AS-BUILT

**Love's Travel Stop &
Country Store - Store #600**
9000 West Interpark Drive, Ingalls, Indiana 46048
Sanitary Sewer Plan & Profile

DATE: 05/15/13	DRAWN BY: kww
ISSUED: 7/7/14	CHECKED BY:
JOB NUMBER: 12110	
SHEET # C401

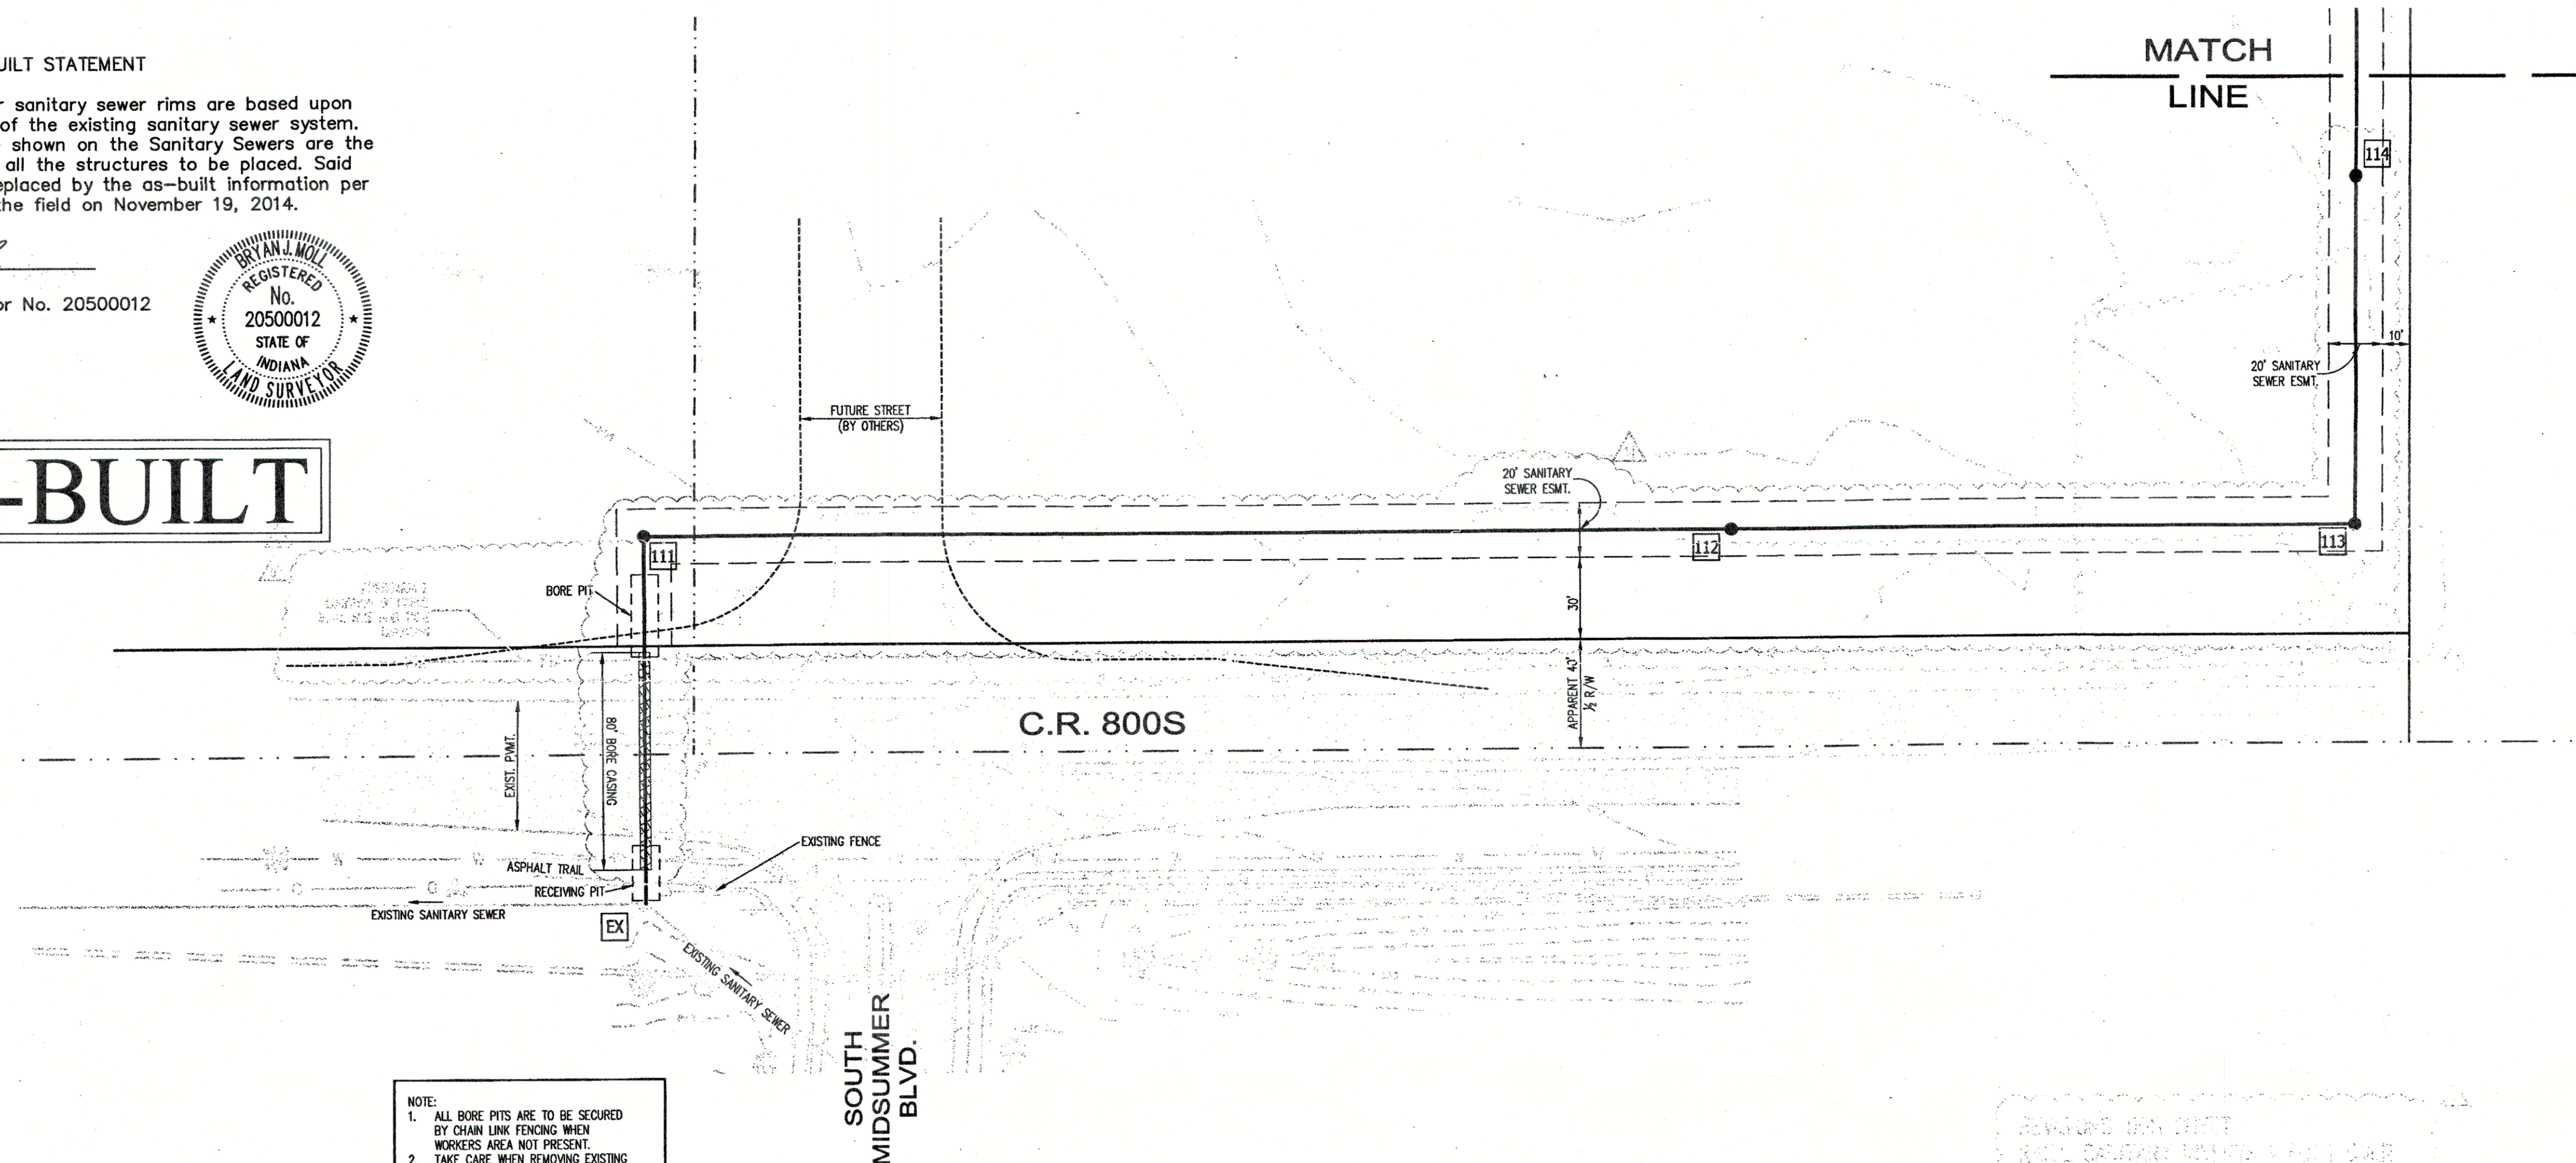
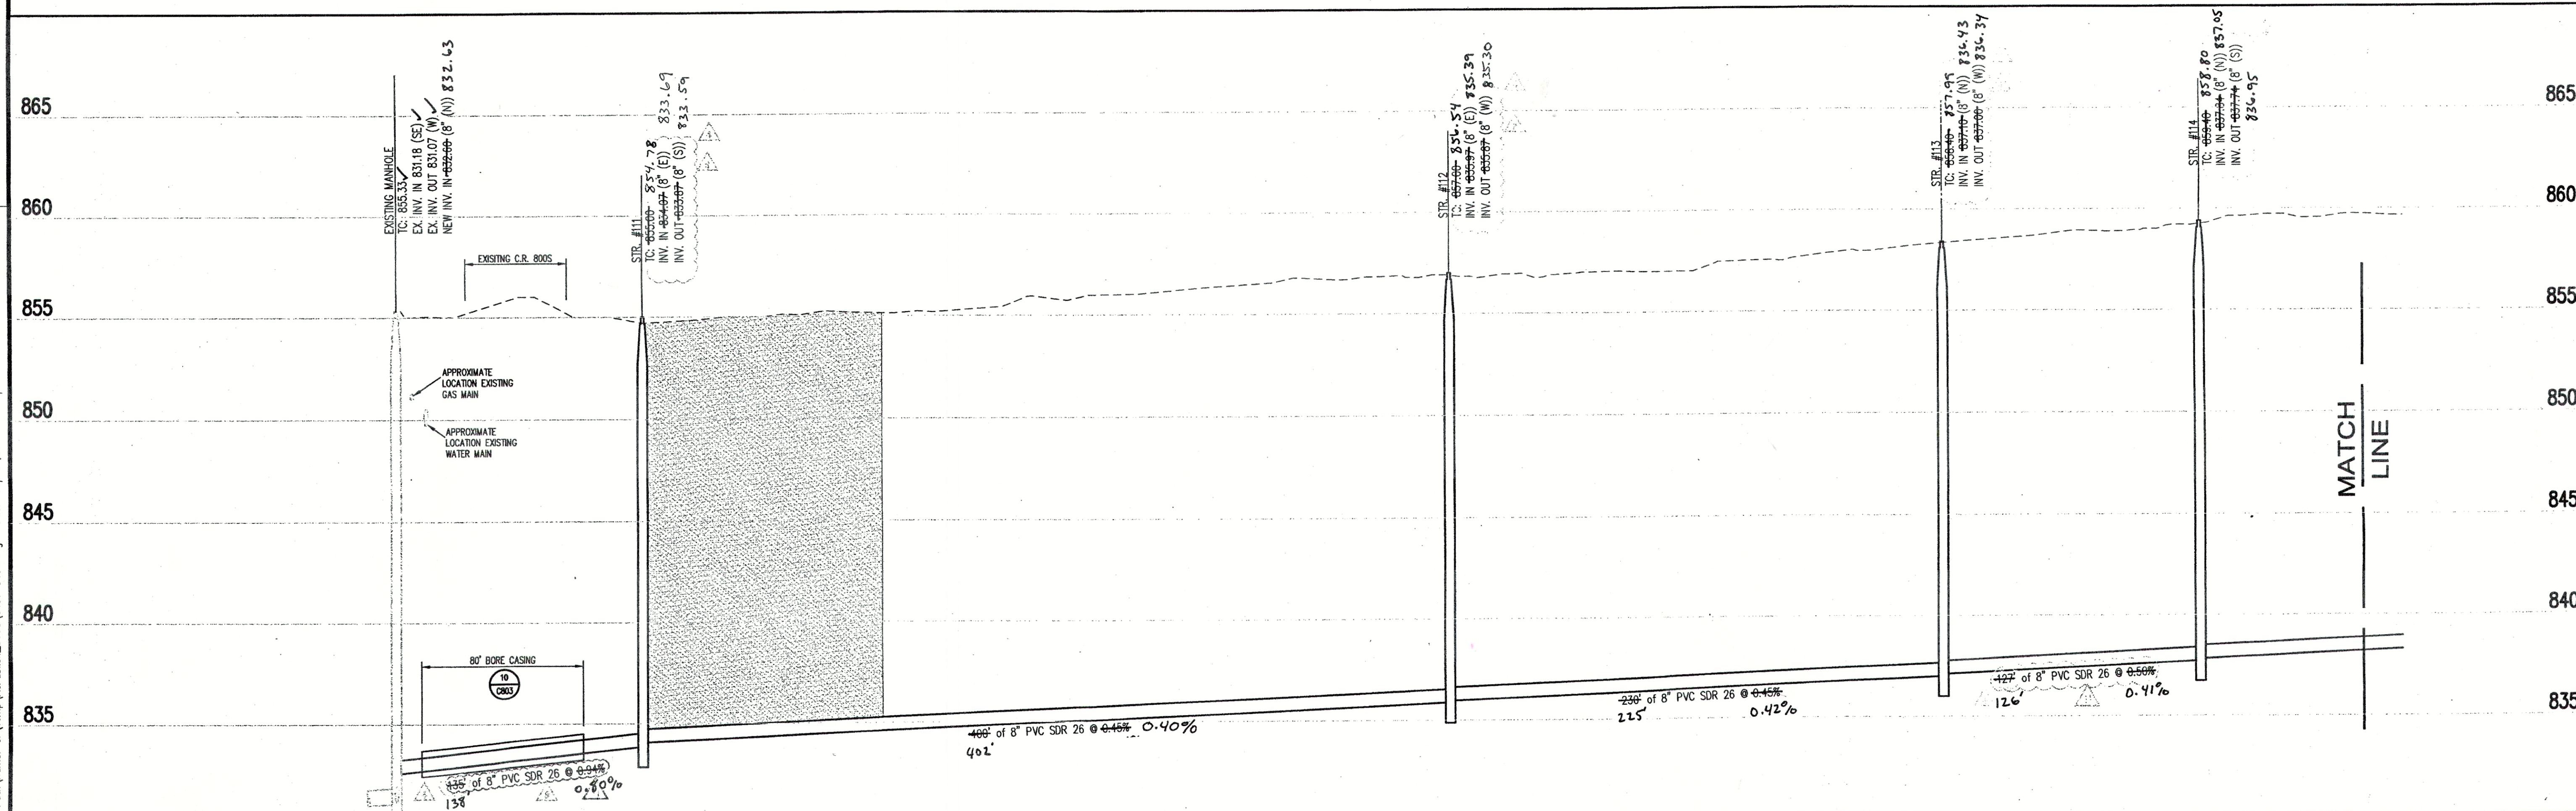
As-Built information for sanitary sewer rims are based upon above ground evidence of the existing sanitary sewer system. The strike through data shown on the Sanitary Sewers are the proposed elevations for all the structures to be placed. Said information has been replaced by the as-built information per elevations collected in the field on November 19, 2014.
